## DESCRIPTIVE REPORT

*Registry No.* ..... H11470

*General Locality* ..... Cape Decision

*Sublocality* ..... Aats Bay and Egg Harbor

**Figure 3: Shadow zone and least depth of a submerged rock off Nation Point**

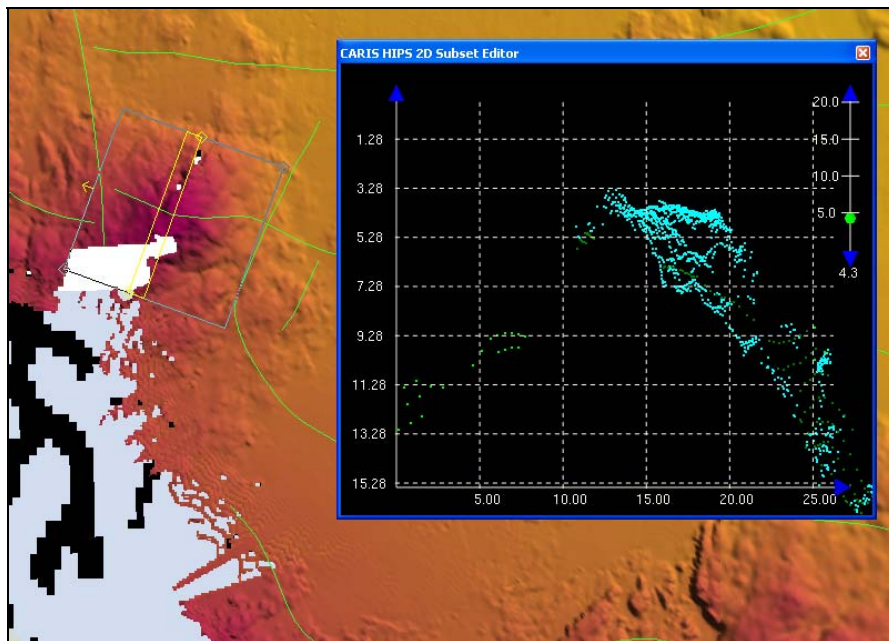
Off Nation Pt, at position 55°55'45.7N, 134°19'54.5W, there is a 30 x 40m holiday in the shadow zone of a submerged rock. The holiday was examined in CARIS Subset Editor (see Figure 3), and the Hydrographer is confident a least depth of 3.4m from the feature was obtained<sup>9</sup>.

<sup>9</sup> Concur

**Figure 4: Holiday resulting from poor line spacing between launches (1.2m resolution surface shown)**

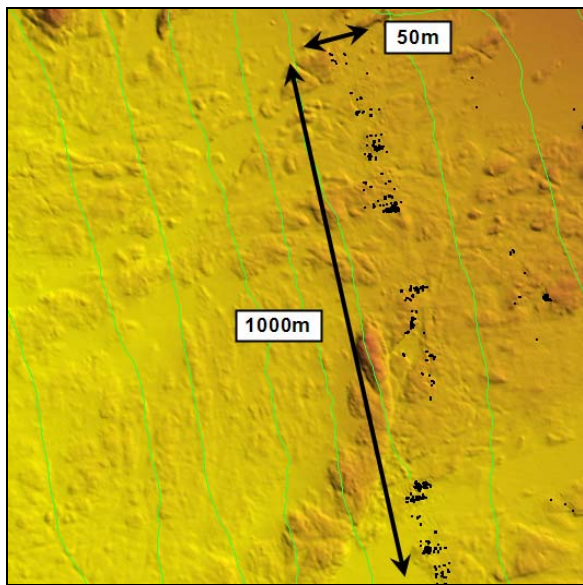
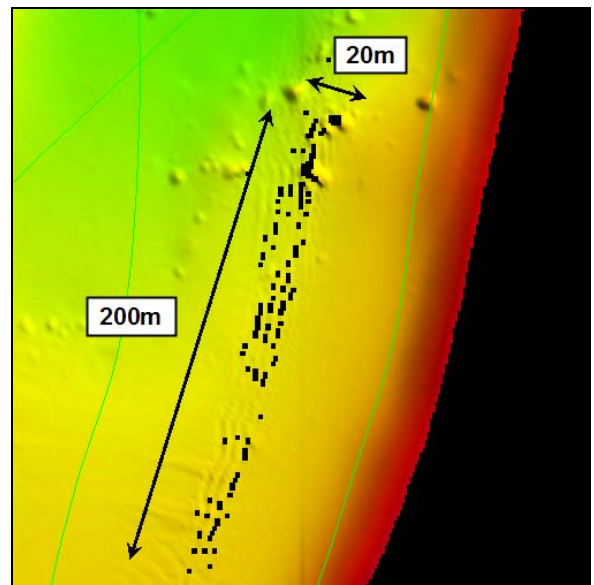
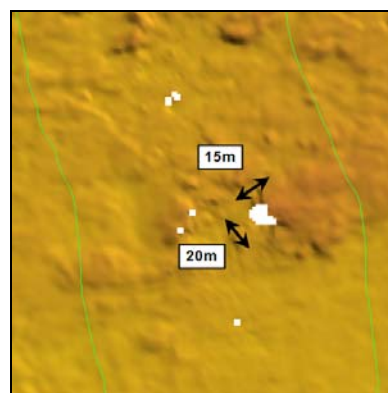
There is a gap in the data collected between Launch 1010 on May 28, 2005 (DN 148) and Launch 1018 on May 29, 2005 (DN 149), east of Windy Peak, resulting in a seam of thin coverage in the area of overlap. As shown in Figure 4, the affected area is approximately 1000 meters long, with a maximum width of 50 meters. A similar holiday developed in the southern end of Aats Bay where Launch 1018 provided insufficient line spacing (see Figure 5). The backscatter imagery of the two affected areas was examined, in addition to the data being thoroughly reviewed in CARIS Subset Editor. The Hydrographer is confident the least depths of all features are represented in the BASE surfaces and no additional contacts were noted<sup>10</sup>.

<sup>10</sup> Concur

**Figure 6: H11470 holidays in 2.0m surface (left) and 1.2m surface (right)**

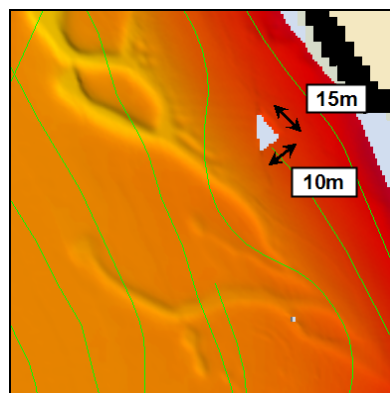
There are two spot holidays (Figure 6) that just exceed the three node metric in survey H11470:

- 55°54'50.6"N, 134°18'52.0"W, 15m by 10m holiday at a depth of 7m
- 55°53'10.0"N, 134°21'13.4"W, 20m by 15m holiday at a depth of 30m

In both instances, the backscatter imagery was examined with CARIS Side Scan Editor revealing no contacts. Additionally, the surrounding area displayed no trend towards shoaling<sup>11</sup>.

<sup>11</sup> Concur with clarification. Holidays are not navigationally significant and have not been included in the HCell.

Figure 7: Data gaps resulting from transmission breaks in the MBES (1.2m resolution surface shown)

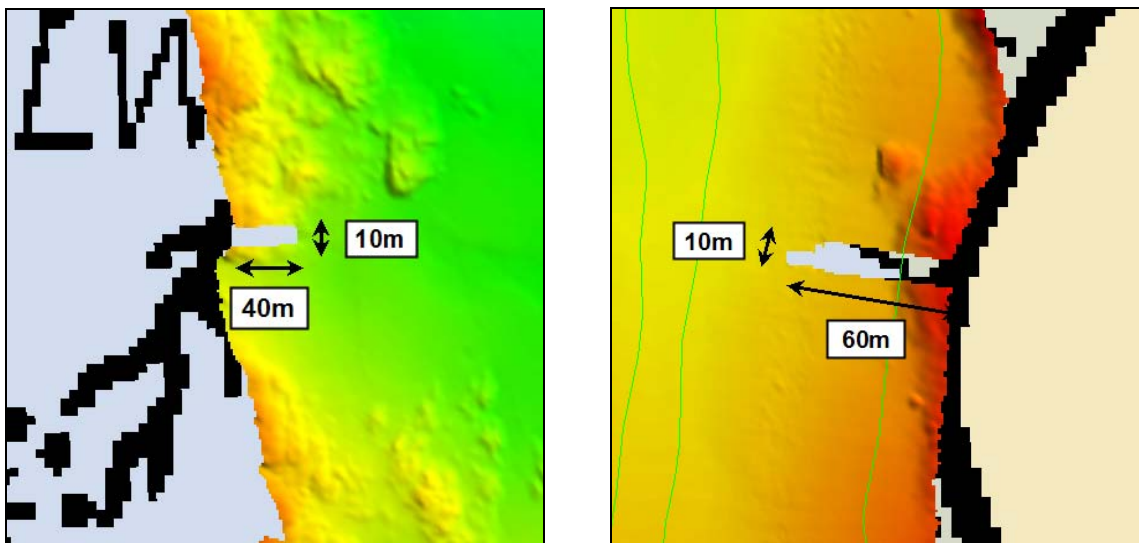
On May 28, 2005 (DN 148) the RESON 8101 on Launch 1010 experienced a strange data transmission error. The MBES was otherwise performing well until it experienced a logging blackout of 3 to 4 seconds (lines 148-2242-1 and 148-2221). These intermittent transmission losses resulted in data gaps of size 10m by 40m and 10m by 60m in the 1.2m resolution surface shown in Figure 7. Other than the small gaps, the MBES data quality does not appear to be affected<sup>12</sup>.

<sup>12</sup> Concur

**Figure 6: Depth comparisons between H11470 and chart 17402. Note: A “+1” indicates surveyed depths are 1 fathom shoaler than charted depths. Soundings A, B, C and D differ from the charted depths by more than three fathoms.**

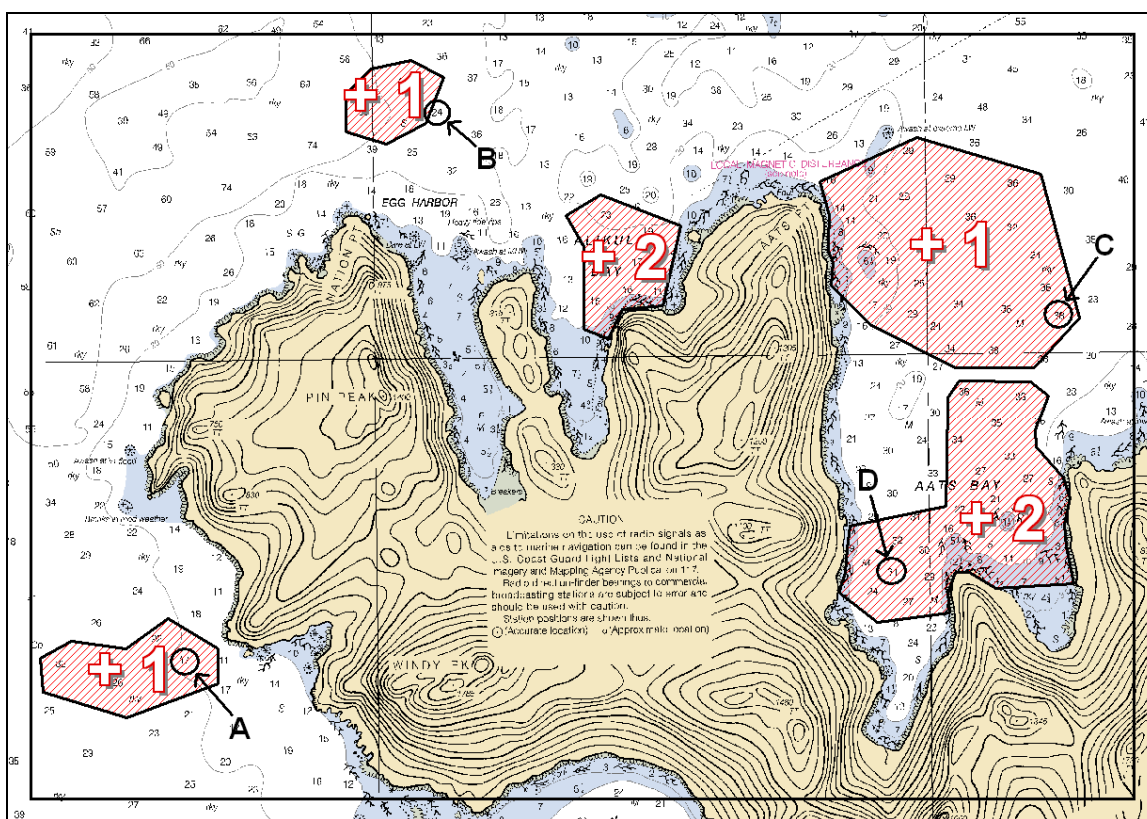
Depths from survey H11470 generally agreed or were one to two fathoms shoaler than depths on chart 17402. As shown in Figure 10, both Alikula Bay and the south end of Aats Bay had measured depths averaging 2 fathoms shoaler than charted. Three areas (northern Aats Bay, north of Nation Point and west of Windy Peak) had measured depths averaging 1 fathom shoaler than charted.

There were four soundings (see Figure 10) on chart 17402 that had a difference exceeding three meters from the depths collected during survey H11470:

- A.  $55^{\circ}53'30.28''\text{N}$ ,  $134^{\circ}21'44.66''\text{W}$  – 4.4 fathom shoalest sounding at a charted 17 fathom sounding<sup>17</sup>.
- B.  $55^{\circ}56'13.79''\text{N}$ ,  $134^{\circ}19'28.19''\text{W}$  – 36.8 fathom shoalest sounding at a charted 24 fathom sounding.
- C.  $55^{\circ}55'10.02''\text{N}$ ,  $134^{\circ}13'45.40''\text{W}$  – 30.8 fathom shoalest sounding at a charted 38 fathom sounding.
- D.  $55^{\circ}53'51.96''\text{N}$ ,  $134^{\circ}15'23.47''\text{W}$  – 26.7 fathom shoalest sounding at a charted 31 fathom sounding.

<sup>16</sup> Chart comparisons were performed with the most recent edition of chart 17402, 1:40,000 (11<sup>th</sup> Ed., Dec. 1, 2005, NM 10/12/05). General agreement was found between the field comparison and office comparison.

<sup>17</sup> Submitted as 4 fathom 2 foot DTON from the Branch and retained in the HCell

Figure 1.1.1

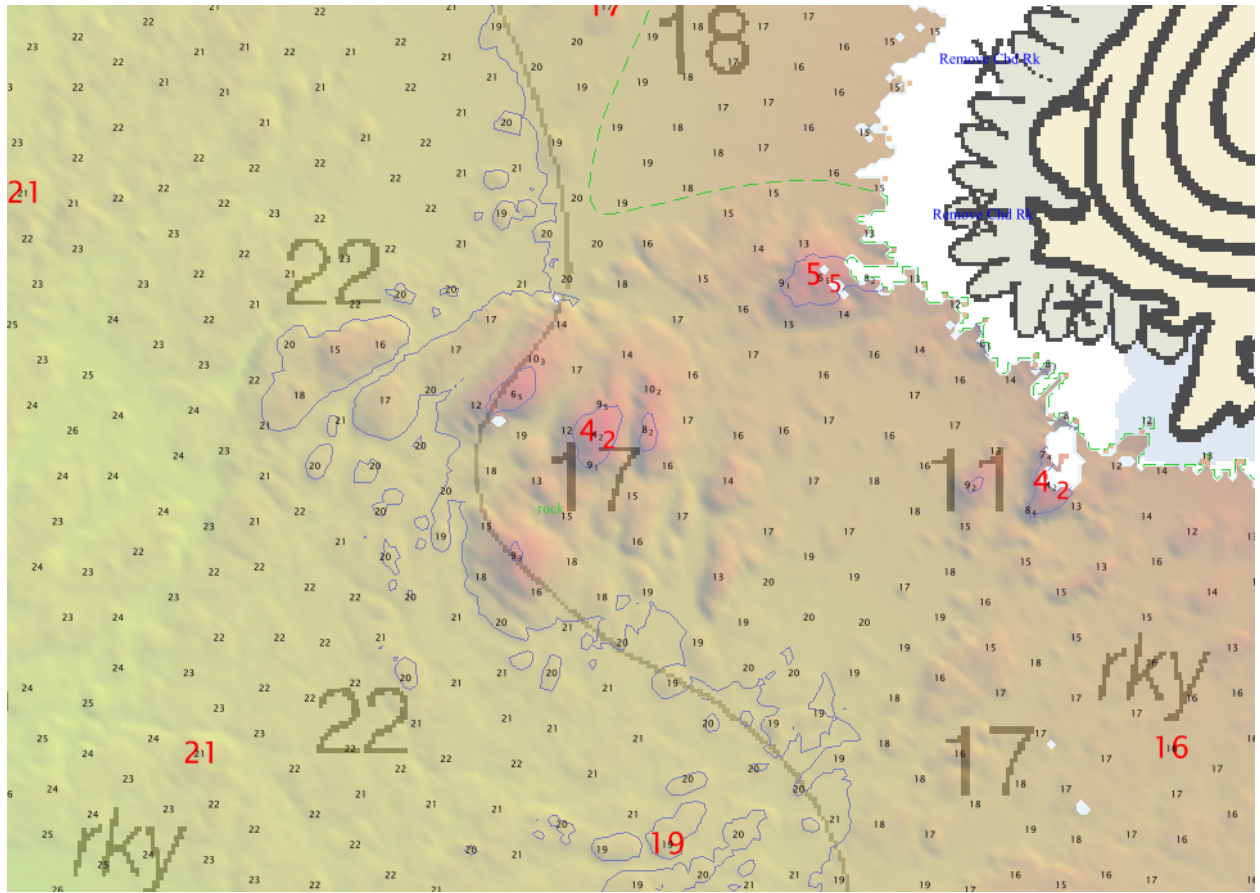
CEF RK NEW EXT CFF LDG

Chart rock and extend CFF ledge
